Suite 407.
ORIGINAL LAYOUT
INVENTORY SUITE
(OLD)

SUITES 407 - NOYAC BAY (Inventory suite)

Royal Pine Homes 25 Baker Hill Blvd - Stouffville, ON Apr 04, 2018

(NEW)

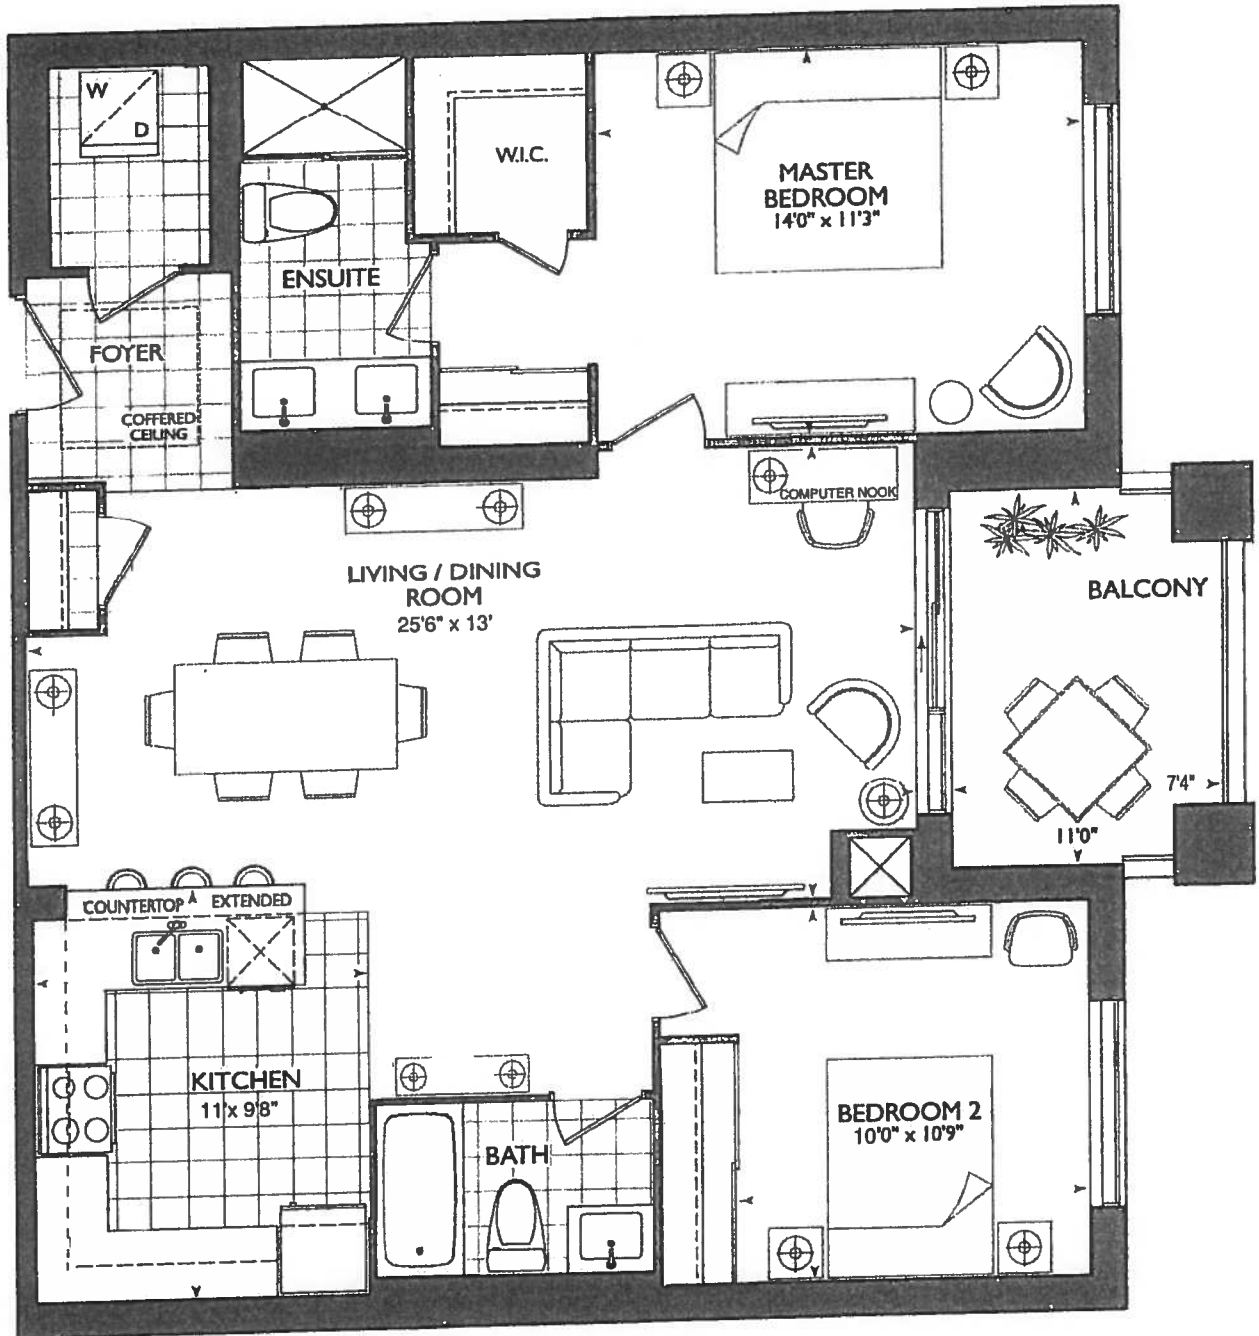
- (x2) CAPPED PENDANT
- (x1) PLUG PENINSULA
- (x) PUCK LIGHTS

- NEW PLAN
- REMOVED DEN
- REVISED KITCHEN

***REVISED LAUNDRY DOOR SWING &
ENSUITE WALL AS PER THIS BROCHURE**

**#1- KITCHEN LAYOUT WITH 1ST UPG.
APPLIANCE PACKAGE**

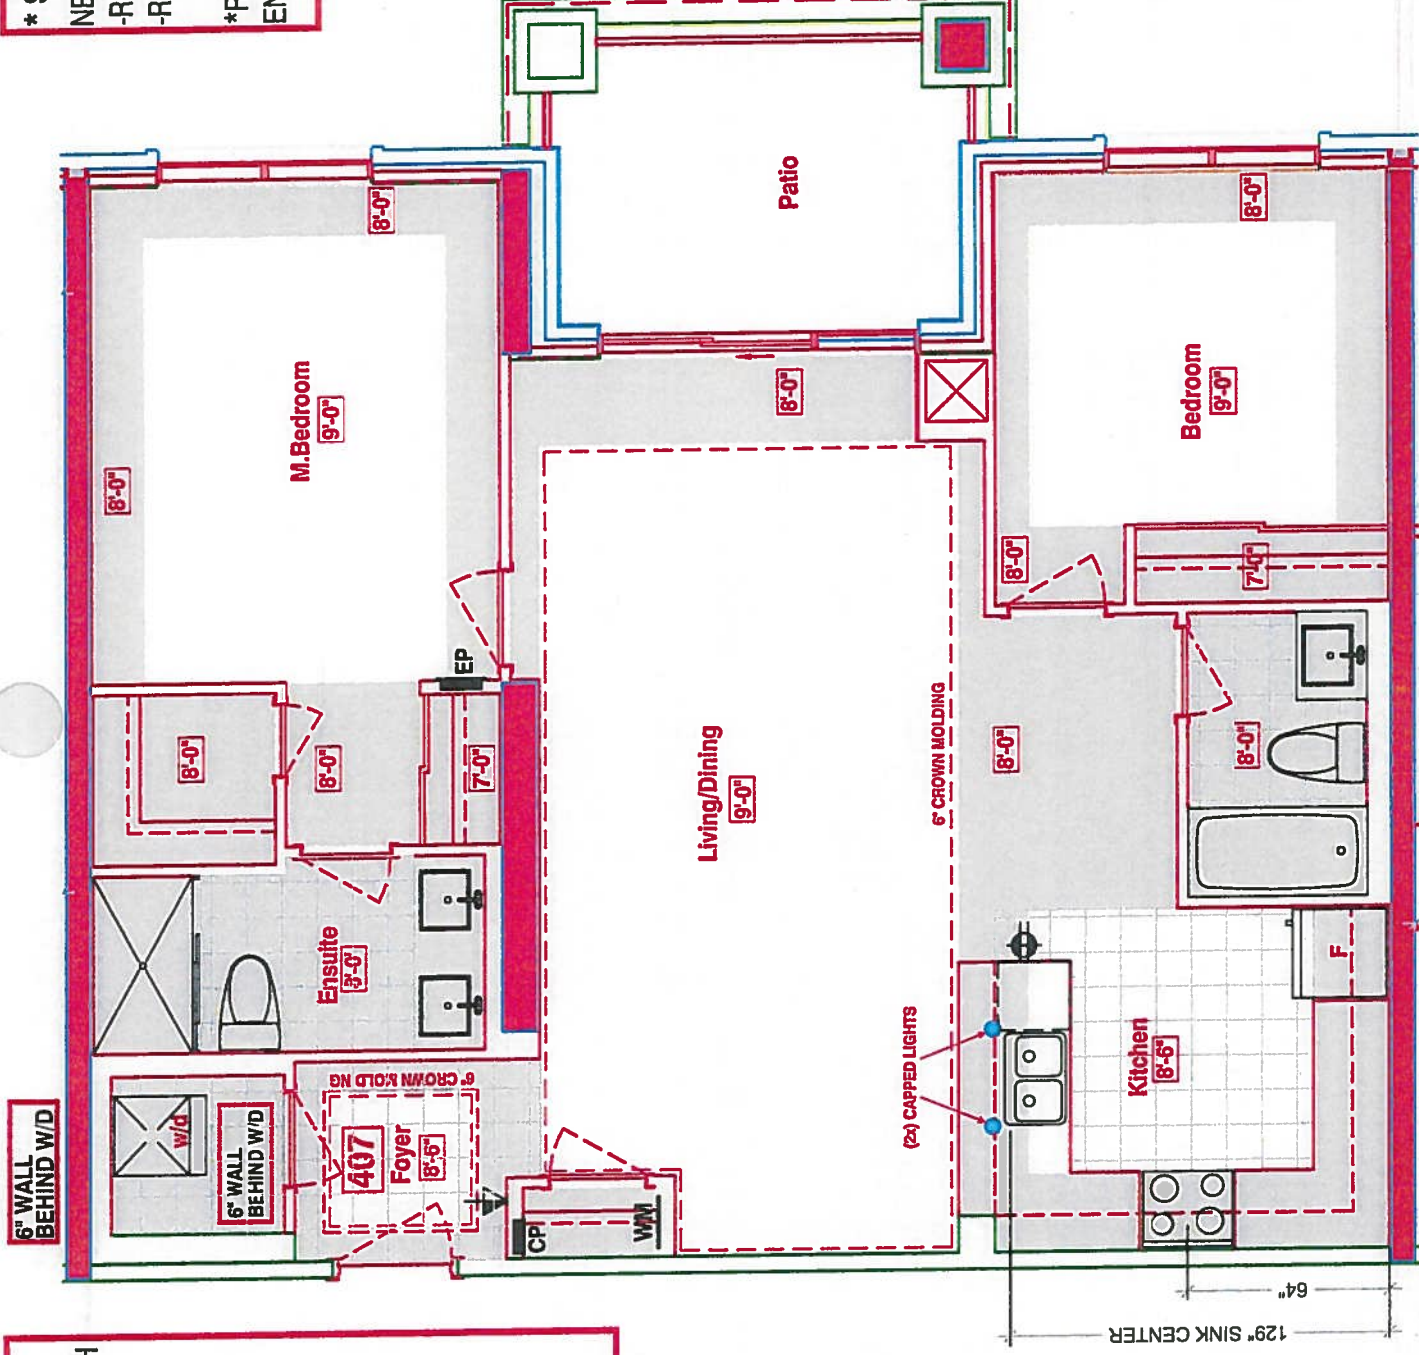
CHOICE OF STD. KITCHEN LAYOUT WITH
STD. APPLIANCE PACKAGE

CAN UPGRADE AT DECOR CENTER

***SEE ATTACHED UPG.**
